CONVERSION TO ONE PIECE ALL ALUMINIUM “PADLESS” YOKE SLIDE ASSEMBLY

For further information about the Conversion to one piece all aluminium “padless” Yoke Slide Assembly, please contact either of the references at Carnaudmetalbox Engineering detailed below, quoting the technical bulletin number **TB-B3/B4-006**.

New Yoke Slide Assembly (Without bronze running pads)

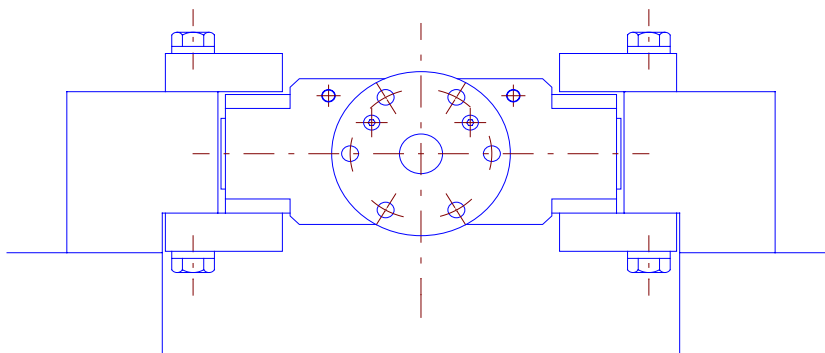
SUMMARY: CarnaudMetalbox has developed as part of the new Mark II series 5000 Bodymaker an all aluminium one piece Yoke Slide Assembly which does not have any bronze running pads. This new arrangement provides for a simpler and more accurate design and eliminates the bronze pads which are often subject to corrosion attacks by acids formed in the lubricating oil.

An upgrade kit of parts is now available for all existing B3 / B4 Bodymakers to convert to the new one piece aluminium “Padless” Yoke Slide.

This upgrade kit is applicable for all B3 / B4 Bodymakers Currently fitted with the aluminium Yoke Slide
